APPENDIX J

City of Madison Coordination

Subject: Staff Comments on North Stoughton Rd Design Alternatives, version 3. With Transportation Commission Comments

Subject: WisDOT
North Stoughton Road Project
City of Madison Staff Comments

Figure 1 Corridor Access Spacing

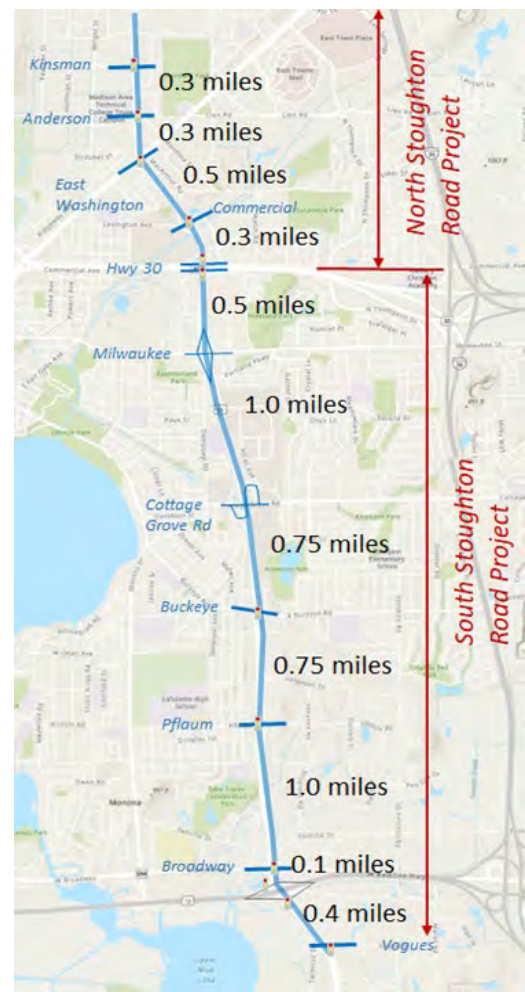
- Speed – Madison believes speeds greater than 45 mph should be reserved for a fully access controlled facility. Angle crashes at high-speed signal-controlled intersections have much greater probability of severe injury or death. Since a fully access controlled facility is not proposed and would be difficult to achieve, the facility should migrate towards an urban roadway with corridor speeds generally between 35 to 45 mph, with the lower speed limit strongly preferred.¹ Note that speed is unrelated to capacity and both low and high-speed arterials can carry similar amounts of traffic.

- Consistency – To the extent possible, Stoughton Road should maintain a facility type for the longest stretch possible. Changing between urban roadway, expressway, freeway, back to expressway or urban roadway leads to confusion and fosters inconsistent speeds and driver behavior. Because of the closely spaced side roads on the northern portion of the corridor,

Figure 2 Stoughton Road/East Washington Alternatives

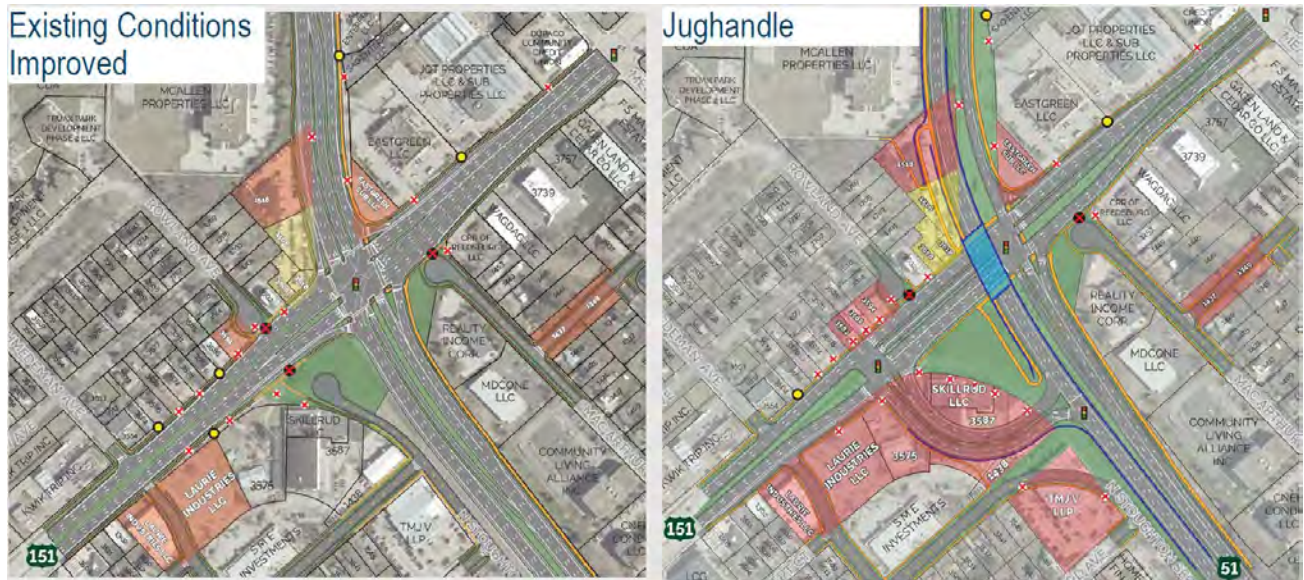
For the remaining alternatives, Madison prefers the at-grade intersection alternative over the jug-handle intersection alternative. While providing better ped/bike crossing, the jug-handle only removes 15 to 20 percent of the traffic from the intersection yet requires over 20 driveway closures and 11 relocations. The impacts are large and permanently preclude investment/development of almost 10 acres of land.

Madison requests that the driveway closures be reduced to the extent possible. These driveways have operated as right-in/right-out for decades with little effect on injury crashes. We believe maintaining these driveways does not pose a significant safety risk and will prevent at least 5 relocations.

Figure 3 Commercial Avenue Alternatives

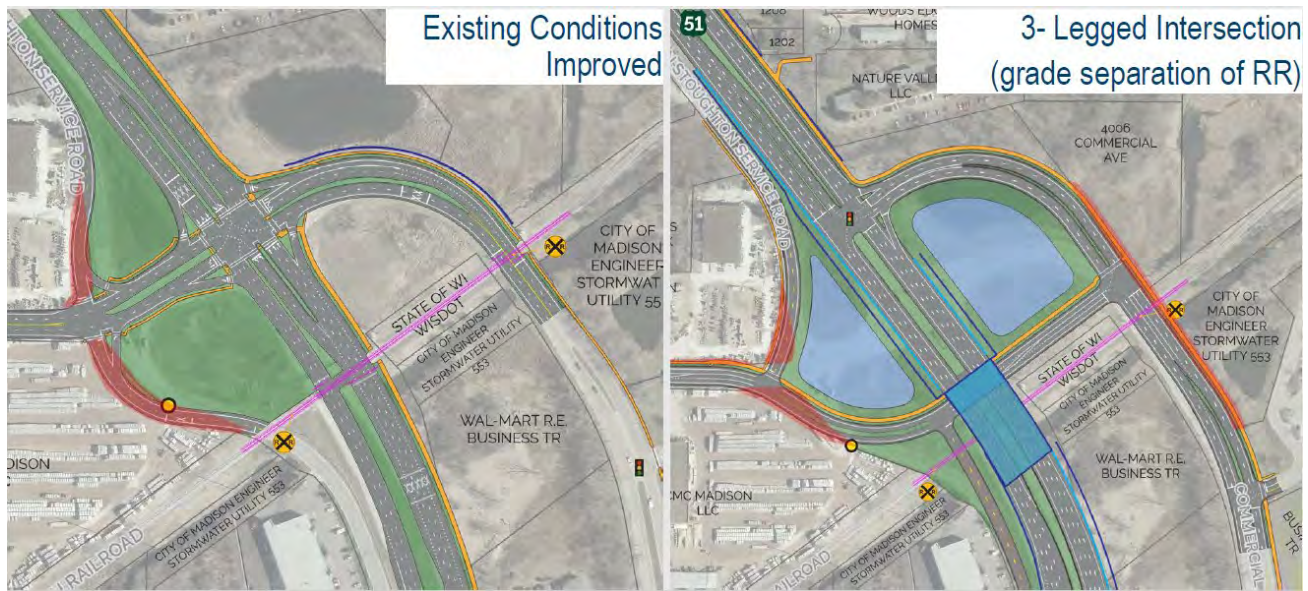
Staff support the partial jug handle over the existing conditions alternative. It provides a local road connection across Stoughton Road with an “All Ages and Abilities” crossing for bicycles and pedestrians. The jug handle restores the grade separated crossing of the railroad that existed prior to 1990, aiding in the restoration of passenger rail. If restored, the grade separation would eliminate crossing exposure and substantially decrease crossing risk. Discussions with Amtrak representatives also indicate that they strongly prefer an alternative that includes a grade separation of the railroad.

Figure 4 Highway 30 Alternatives and Pedestrian Routing

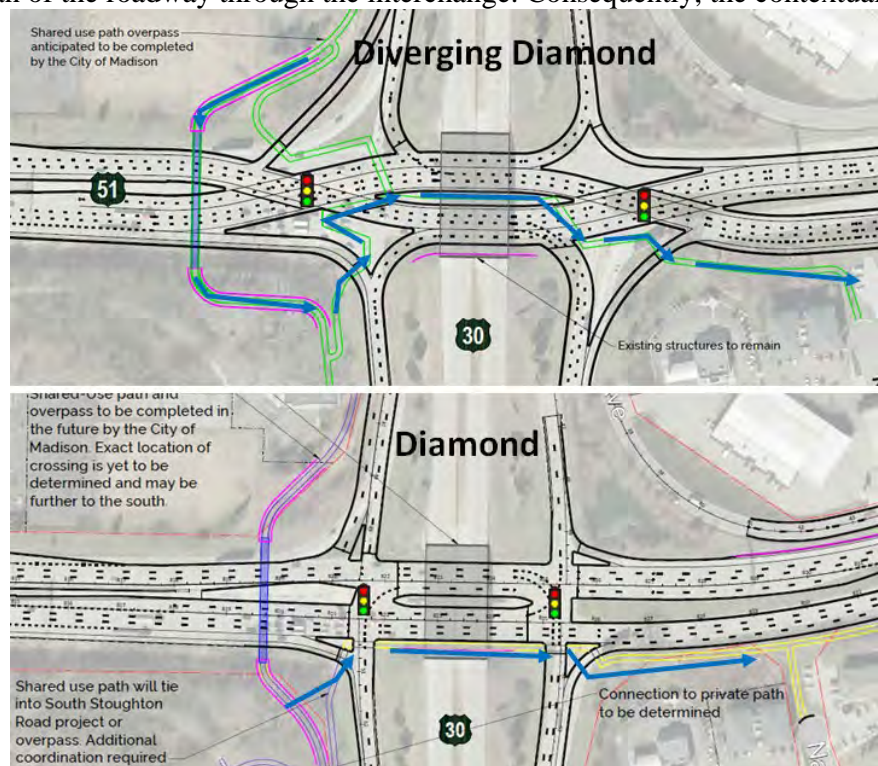
Madison prefers the conventional diamond interchange over the diverging diamond interchange. While north-south pedestrian/bicycle volumes are not anticipated to be large, the crossings of a diverging diamond are not “All Ages and Abilities”. The diverging diamond requires pedestrians and cyclist to cross and walk along the median of the roadway through the interchange. Consequently, the contextual clues used by the visually impaired do not exist. Also crossing to and walking/biking in the unprotected median would be challenging for younger users. The conventional diamond does not decrease operations significantly and we believe provides a more intuitive and safer facility for vulnerable users.
